Michael Vanderhurst, Chair, Economic Development & Planning Commission
Commissioner Jennifer Burrows, Vice Chair
Commissioner Paul Chang
Commissioner Jessica Kennedy
Town of Mammoth Lakes
437 Old Mammoth Rd. Ste R
Mammoth Lakes, CA 93546

The Town Planning Division's RESOLUTION NO. PEDC 2022-03 states:

2. Inconsistent with the Lodestar Master Plan for Maximum Height .

Subject: Opposition to proposed Villas-III development plans at 100 Callahan Way

1.1 Emergency Access Gate on Dorrance Dr.

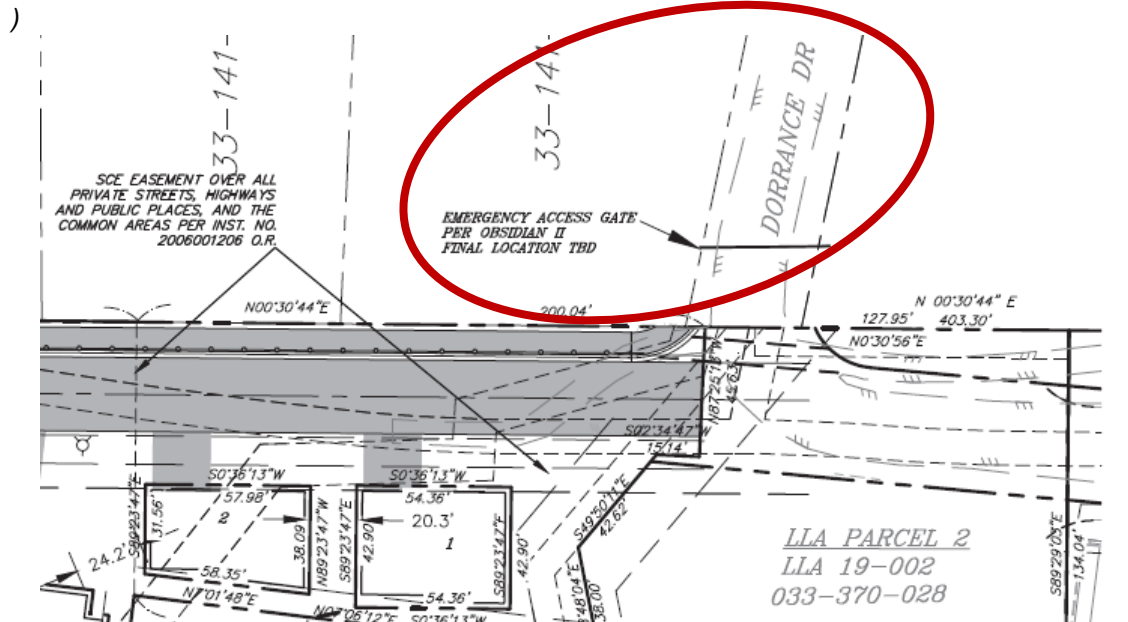
To add to the inconsistency, the Tract Map does not show the new road connecting to Obsidian Place. This property LLA PARCEL 2: LLA 19-002 033-370-028 is not yet developed. [ATTACHMENT 1.4]

This statement is inconsistent with the Resolution (pg. 39) which states Callahan Way and Dorrance Ave. as the access points and is inconsistent with the Project Plan’s Tract Map (pg. 2) which shows Dorrance Ave. as an emergency exit. Additionally, there is no evidence that Obsidian Private Residence Club Association has or will grant passage through their private access gate from Meridian Blvd.

2.2 HOMES WITH 37'-6" HEIGHT , and HIGH CEILINGS ON 2 FLOORS

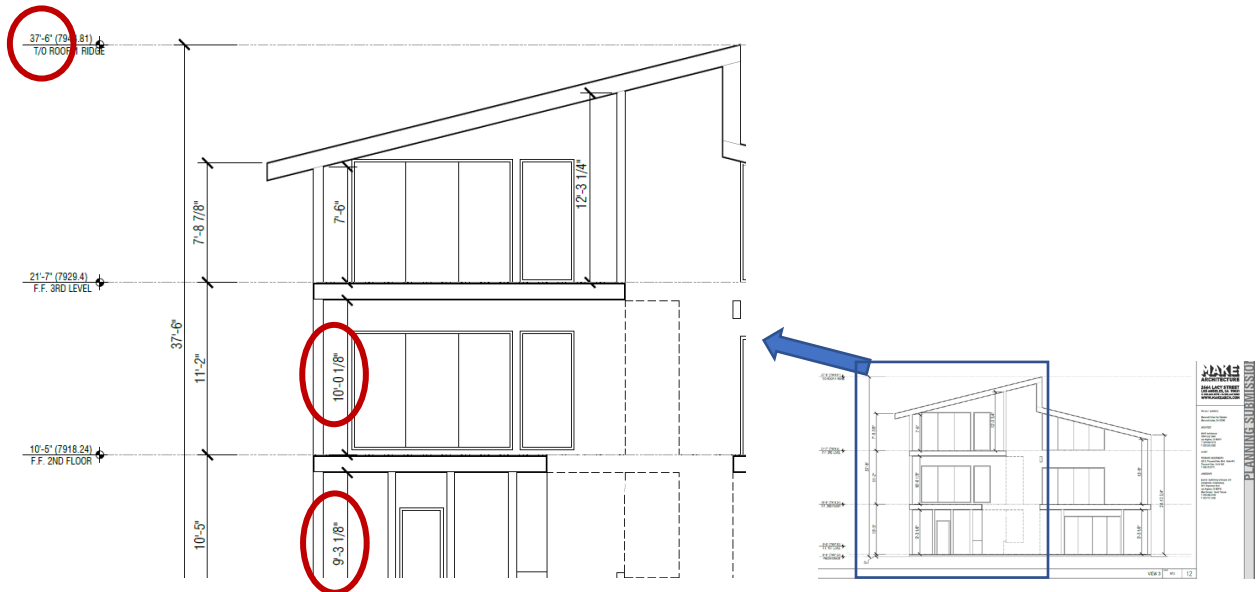
The submitted Single-Family Residence Renderings show building heights of 37'-6". The Home on Lot 1 has three-stories with ceiling heights of 7'-6", **10'-0"**, and **9'-3"**. [ATTACHMENT 2.2] **High ceilings on 2 of 3 floors is the reason these homes exceed the maximum building height.**

The Project Plan's Single-Family Renderings were finalized more than 4 months ago, on 10/29/2021, and there has been significant time to make the design corrections needed. If the 3 extra feet of ceiling height was removed the home heights could easily meet the Master Plan's requirements. The architect and developer need to correct the design to not exceed the 35' maximum height limit.

3.1 SAFER BUILDING DESIGN 3:12 ROOF PITCH

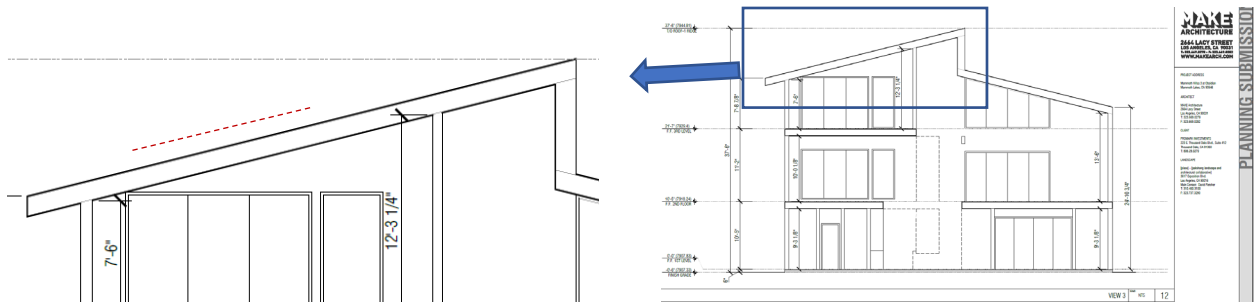
The requested Height Adjustment 21-006 states that the increased height “will result in increased safety of the occupants by allowing for a 3:12 roof pitch.” (Resolution pg. 6 of 178; ATTACHMENT 3.1]. I agree that a 3:12 slope in Mammoth Lakes is safer than a 1.5 :12 slope. Why is this 3:12 safety standard not consistently applied to the duplex roofs that show in the Project Plans have just 1.5 :12 slope? [ATTACHMENT 3.2 – 3.3].

3.3 DUPLEXES = 1.5 :12 ROOF PITCH

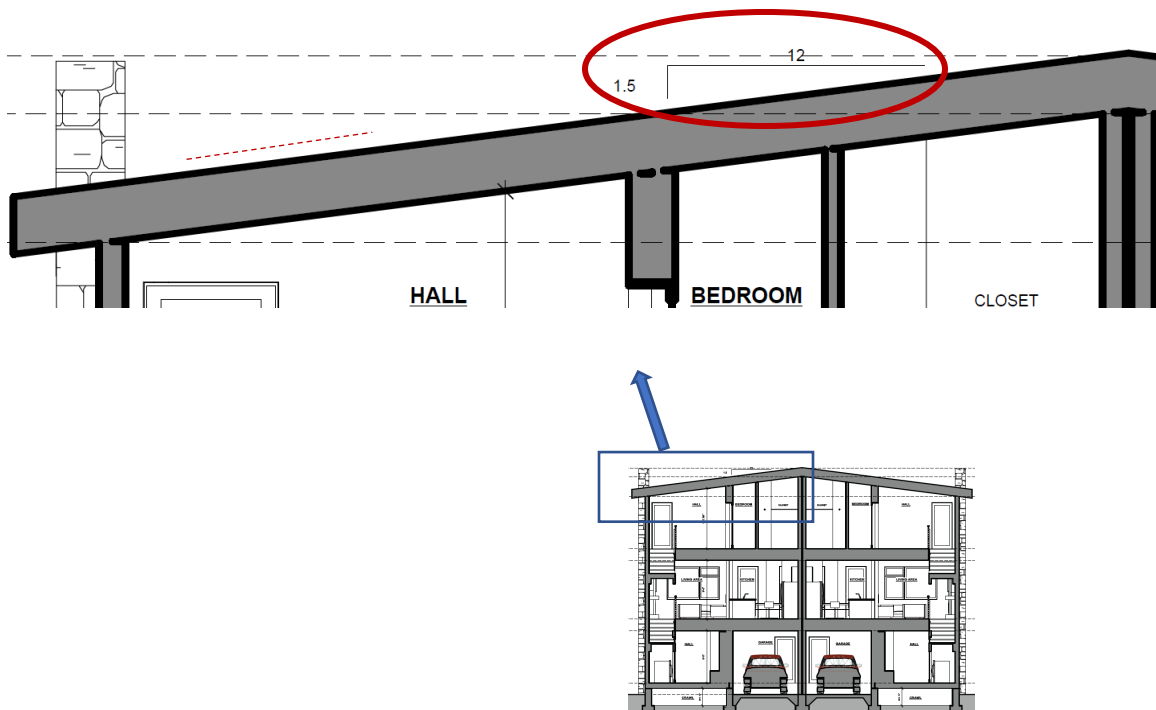
- R3. Evidence and an explanation for why a 3:12 is needed for the homes, but only a 1.5 :12 slope is needed for the duplexes.
- R4. Evidence that the 1.5 /12 slope on the duplexes is adequate for safety of both the inhabitants and SJV Building E.
- R5. Evidence that the 1.5 /12 slope on the duplexes, and units 22-25 specifically, will not cause snow to pile up on the roofs, decreasing estimated sunlight even further.

How does the planning department justify the inconsistency between the rules applied to the single-family homes compared with the duplexes? If the roof slope of the single-family homes needs to be 3:12 for safety then the 3:12 safety standard must be applied to the 15 duplex buildings. In this application the duplexes all have an "unsafe" 1.5 :12 roof slope.

4.1 Existing EASEMENT being Vacated for Villas III

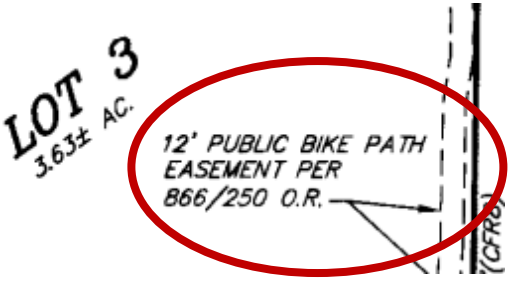
The Tract Map shows that the Villas III development seeks to remove an existing section of the Town Loop Trail and construct a new trail on the eastern edge of the development with a smaller easement. In essence the private Villas III development plans to absorb a portion of the existing MLTS easement, and MLTS has been funded by tax initiative Measure R.

4.2 Villas III Proposed Reduction to Existing 12' Easement to 11.5'

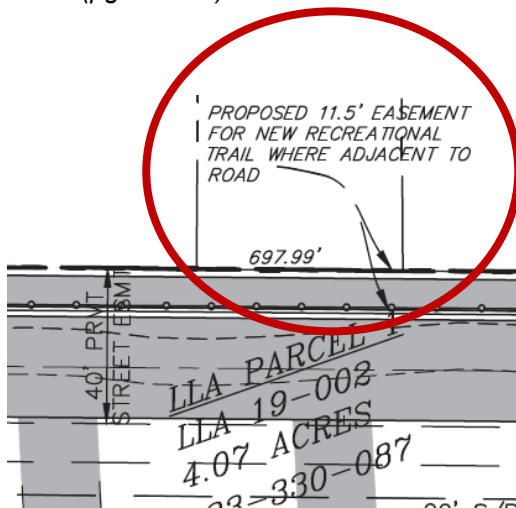
The inconsistency between the plans and the staff report with respect to the easement width (11.5’ vs 12’) was brought to your attention at the February 09, 2022 public hearing. The planning department has updated page 4 of 22 of the staff report to refer to the 11.5’ to 12’ easement.

Despite the update the inconsistency remains; a 12' easement is being vacated (ref. TM 36-222 sheet 3 of 4, Lot 3); **TTM 21-001 must be updated to provide a 12' easement for the entire length.** Without the update the development will absorb a portion of the easement of the MLTS.

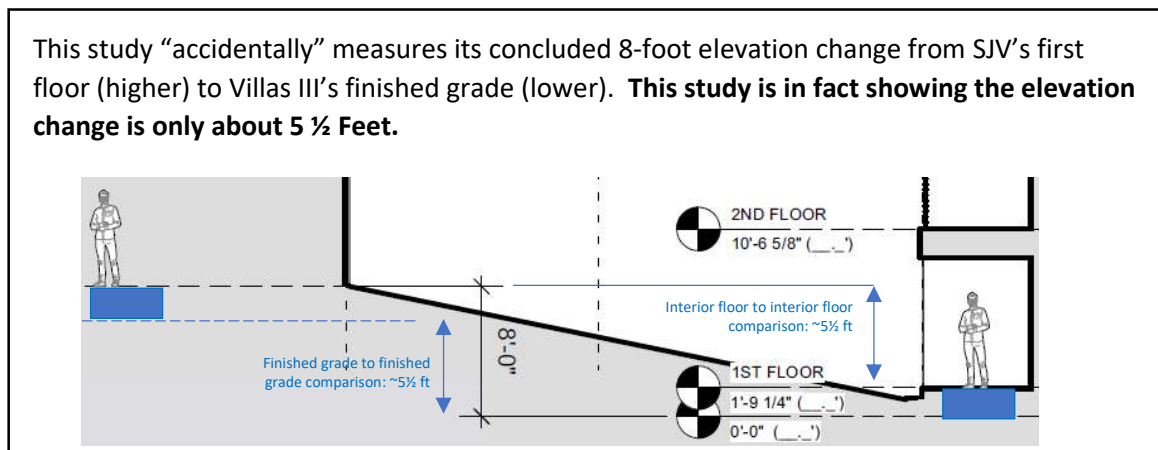
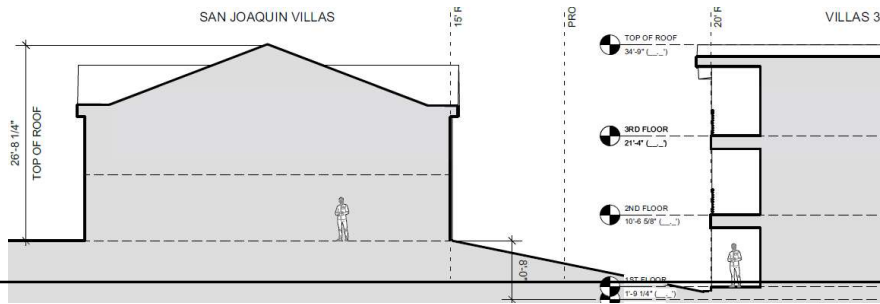
Additionally, this study **misrepresents the relative height** between the SJV E-building and Villas III duplexes by using inconsistent reference points between the two structures. Maximum building height is measured from the finished graded adjacent to the building exterior to the highest roof peak. This “study” does not use “apples-to-apples” references. Both structure heights should be measured from finished grade (indicated by horizontal blue dashed line on SJV image, and the zero-reference on the Villas III image).

By misrepresenting both the SJV image proportion and the incorrect height reference point, this “study” attempted diminish the actual impact of the Villas III duplex 35-foot height.

This “study” also misrepresents the relative **Heights** of the SJV E Building and the Villas III duplexes (p. 69/74). It shows the tops of the 2 buildings to be the same height. It claims SJV is 26’- 8 ¼” and Villas III is 34’ - 9” tall. The actual difference in height would be 8’-3 ¾”. However, the previous paragraph proves that the Elevation Change is actually about 5.5’. Their error is almost 3’ in height, which is an **error of more than 10% relative to SJV’s height**.

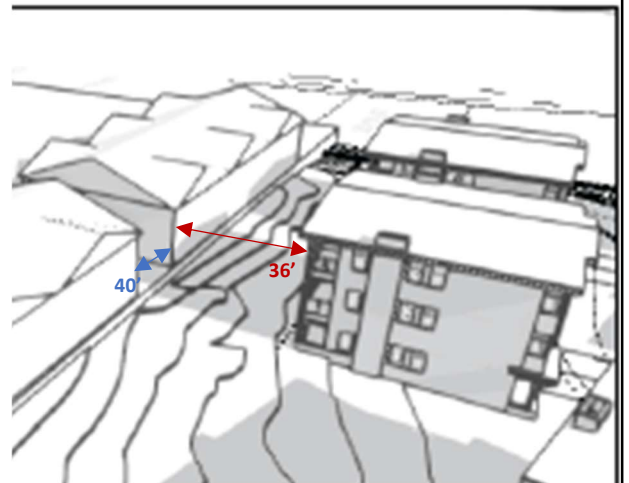
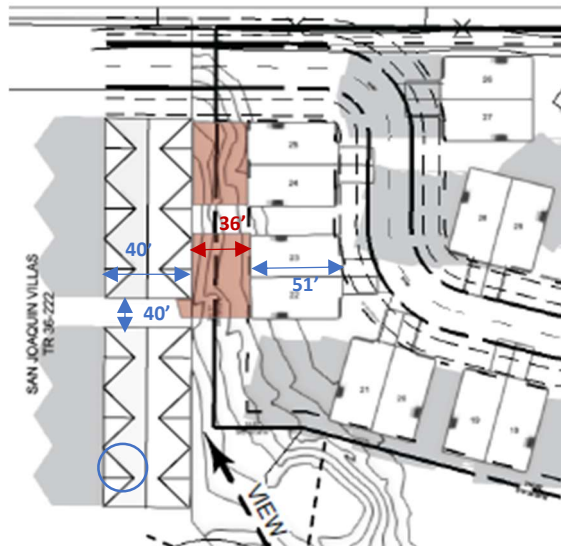
The **distances between buildings** are also misrepresented, as can be seen by the images below with the actual dimensions applied.

The distance between Villas III and SJV E-building (36’) is shown inaccurately as significantly larger than the distance between SJV’s E- and D-buildings (40’).

WINTER SOLSTICE, DECEMBER 21ST

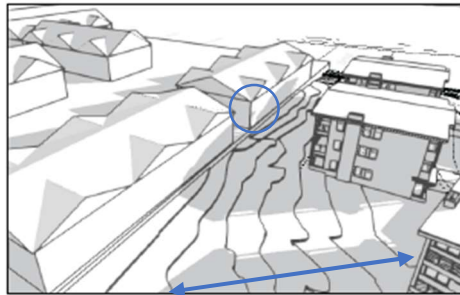
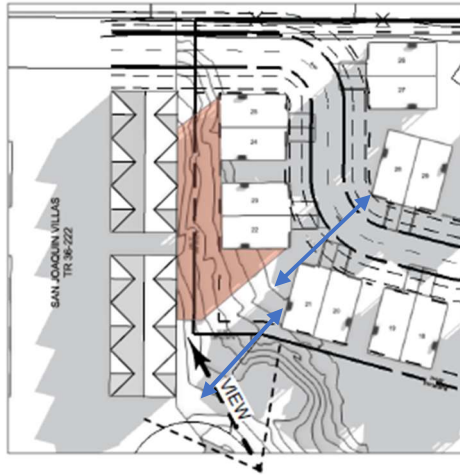
The Solar Study (Project Plans p.72/74) shows these Winter Solstice 9AM long shadows cast by Units 28 and 18-21 (blue arrows) are approximately 120 feet long. The (orange) indicates shadows cast by units 22-25 onto E-building.

These Winter 9am shadows cast by units 22-25 (orange) will impact and overshadow SJV E-building and half of SJV D-building by a significant amount.

Yet this simulated study inconsistently indicates my home will get sunshine during this long shadow period when units 22-23 are just 36' away ?? – inaccurate.

- I. **Eliminate Duplex units 22-25** from the design plan.
- II. **At a minimum**, if those units were to remain included, **require duplex units 22-25 to have an increased setback of 50 feet.**
- III. Independent Shadow Study: Require a **Shadow Analysis be conducted** by an **independent** entity using accurate building / setback dimensions to factually represent the significant negative impact the Villas III Duplex units 22-25 will have on SJV (E-building) during the winter months.

12PM

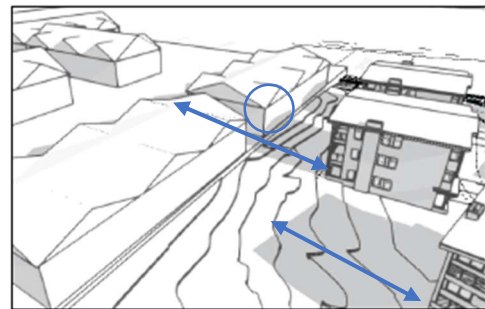
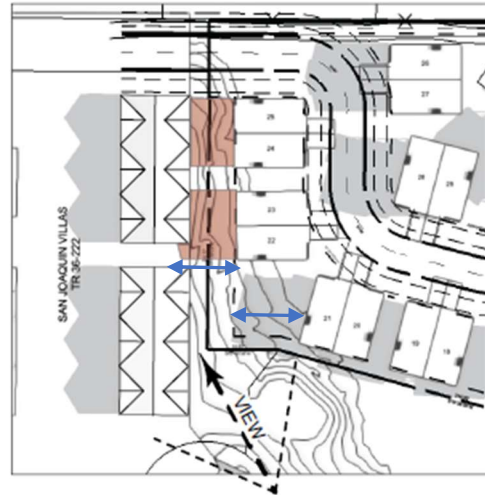
These Winter Solstice 12PM shadows cast by units 21 (shadow length indicated by blue arrow; note both shadow length and width) compared to units 22-25, which are the same size and would cast the same size shadow.
